Access Compliance Report

Public Rights-of-Way

(Curb Ramps)

Intersection ID: 44115	Main Street: RUTHERGLEN_CT	Cross Street: RIDING_HILL_AV	Location: SE
ADA ID: 8754690EC8ED	Ramp Type: BlendTrans1	Initial Pass/Fail: Fail	Overall Compliance: No
			Severity Score: 21.25

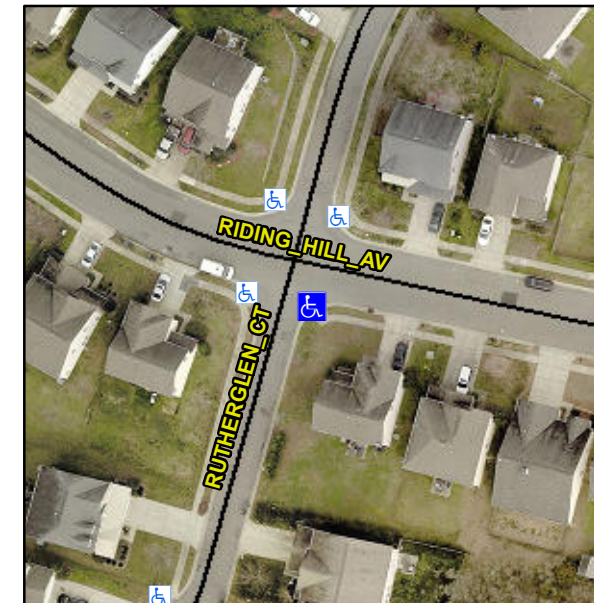
Not Found, R304.5.1, R304.5.3

Compliance	Description	Data	Compliance	Description	Data
N/A	Ramp Length (in)	47.0	Yes	BlendTrans Slope (%)	2.9
No	Ramp Width (in)	38.0	No	BlendTrans XSlope (%)	5.1
N/A	Flare Type LT	N/A	N/A	Flare Type RT	N/A
N/A	Flare Slope LT (%)	N/A	N/A	Flare Slope RT (%)	N/A
N/A	Flare Traversable LT?	N/A	N/A	Flare Traversable RT?	N/A
N/A	Landing Length (in)	N/A	N/A	DWS Provided?	N/A
N/A	Landing Width (in)	N/A	N/A	DWS Contrast?	N/A
N/A	Landing Slope (%)	N/A	N/A	DWS Length (in)	N/A
N/A	Landing X Slope (%)	N/A	N/A	DWS Full Width?	N/A
N/A	Landing Curb? (Y/N)	N/A	N/A	DWS Offset (in)	N/A
N/A	Shared Landing?	N/A			
N/A	Gutter Ponding?	N/A	N/A	Gutter Slope (%)	N/A
N/A	Gutter Lip Ht (in)	N/A	N/A	Gutter X Slope (%)	N/A
N/A	Painted X Walk1?	No	N/A	Painted X Walk2?	No
	X Walk 1 Direction	To NE		X Walk 2 Direction	To NW
	X Walk 1 Width (in)	N/A		X Walk 2 Width (in)	N/A
	X Walk 1 Slope (%)	3.6		X Walk 2 Slope (%)	6.9
	X Walk 1 X Slope (%)	6.7		X Walk 2 X Slope (%)	1.4

N/A	Ramp inside XWalk1?	N/A	N/A	Ramp inside XWalk2?	N/A
	Road Slope (%)	4.3		Clear Space?	N/A
	Road X Slope (%)	5.0	N/A	Clear Space to XWalk (in)	N/A
N/A	Any Obstructions?	N/A	N/A	Storm Grate/Utility Hazard?	N/A
	Obstruction Type			Storm Grate/Utility Type	
		N/A			N/A
			Yes	Surface Condition? (G/P)	Good
			No	Curb Slope (%)	14.9

Remove & Replace Curb Ramp With Two New Directional Ramps or Equivalent.
